# RENESAS TECHNICAL UPDATE

Product Category	MPU&MCU		Document No.	TN-H8*-A371A/E	Rev.	1.00
Title	Information of microcomputer product chip tray (CT022) change		Information Category	Technical Notification		
Applicable Product	See Below	Lot No.	Reference Document	See Below		
		All lots

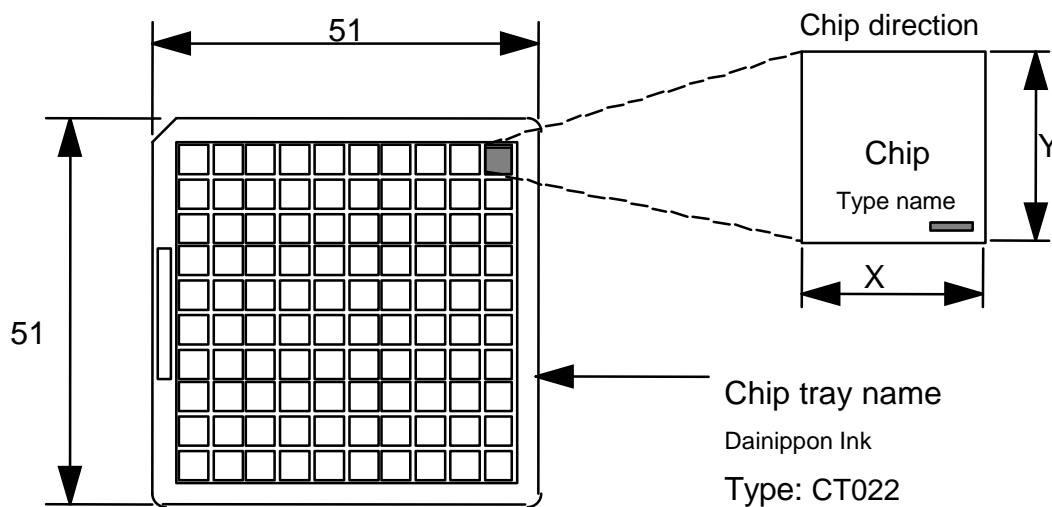
No	Item	[Before Changes] Chip tray Specification	[After Changes] Chip tray Specification
1	Type name	CT022	CT290
2	Depth of pocket *1	0.6±0.1(mm)	0.8±0.05(mm)
3	Back of chip tray	Flat	With Projection
4	Protection seat	Included	Not Included

\*1 The clearance value of the depth of the pocket is not changed.

Chip tray Specification (Before it changes)

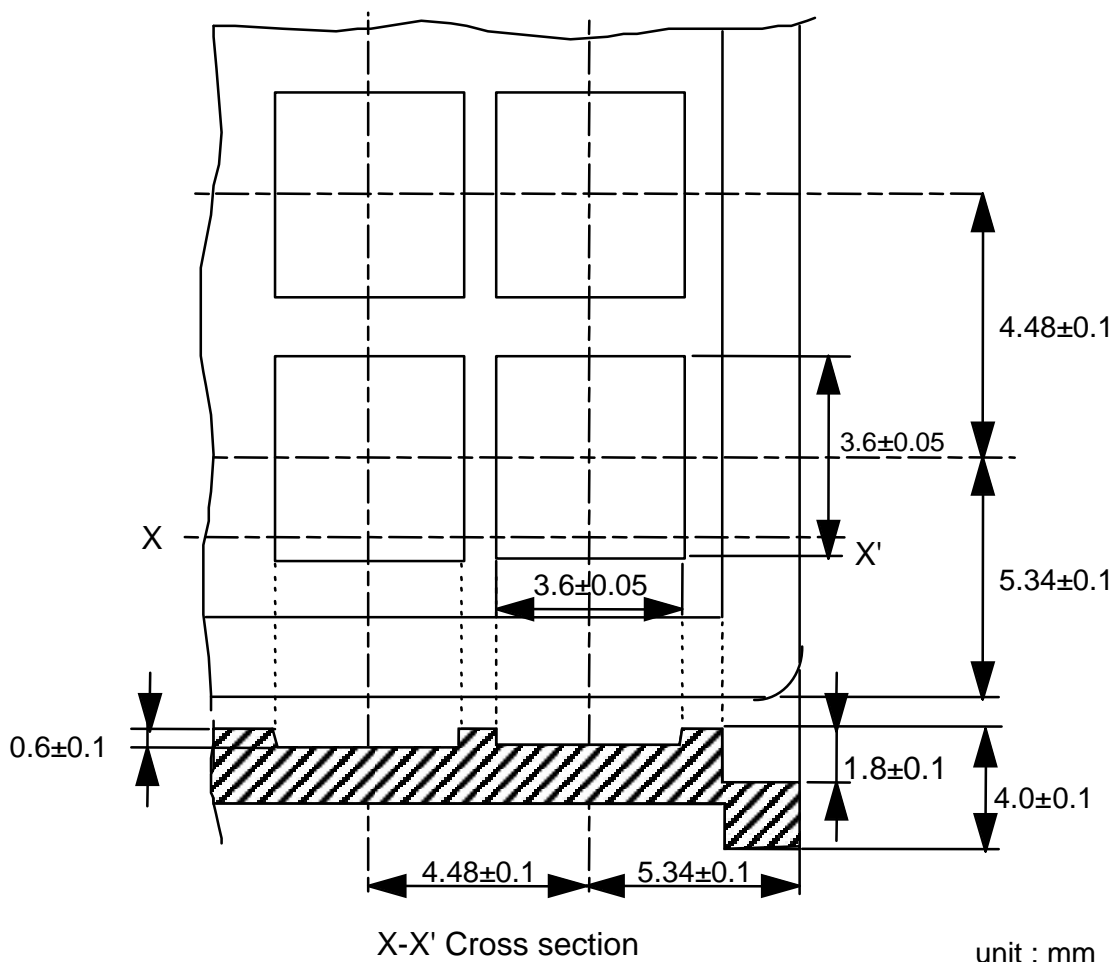
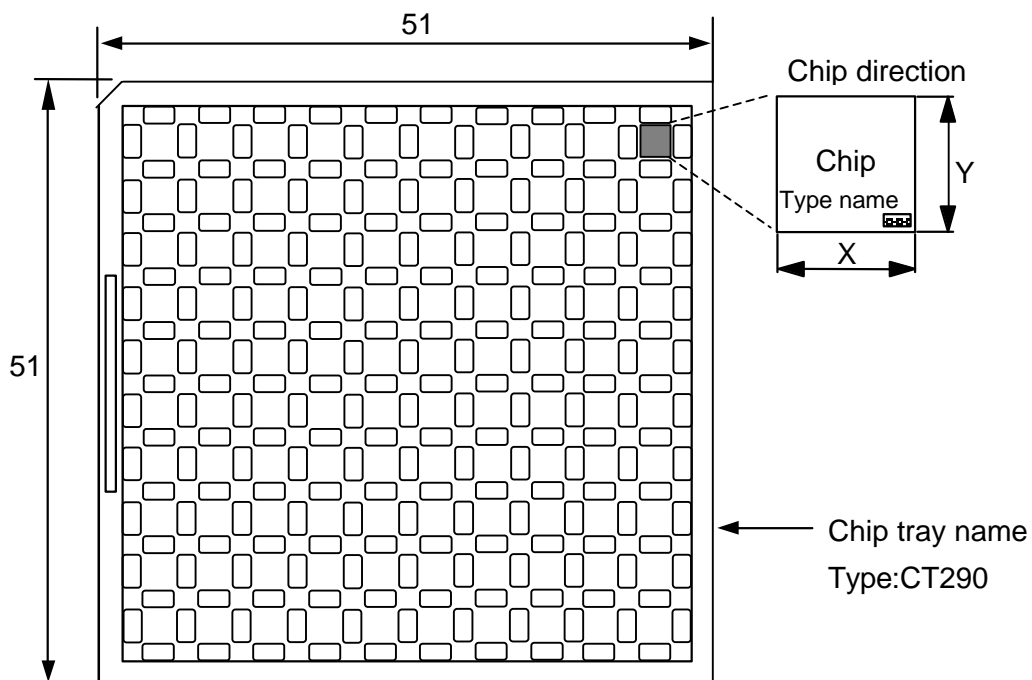
Carved code:TCT036036-060

Chip tray Specification [After it changes]

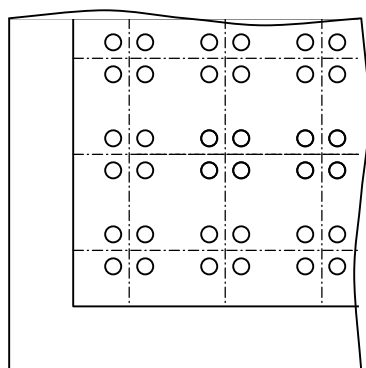
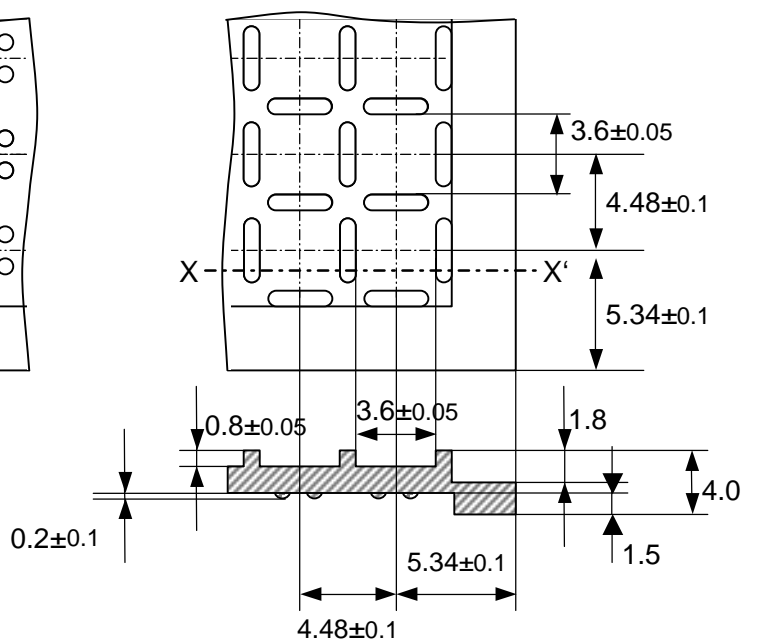
Carved code:TCT036036-060T

Back of chip tray
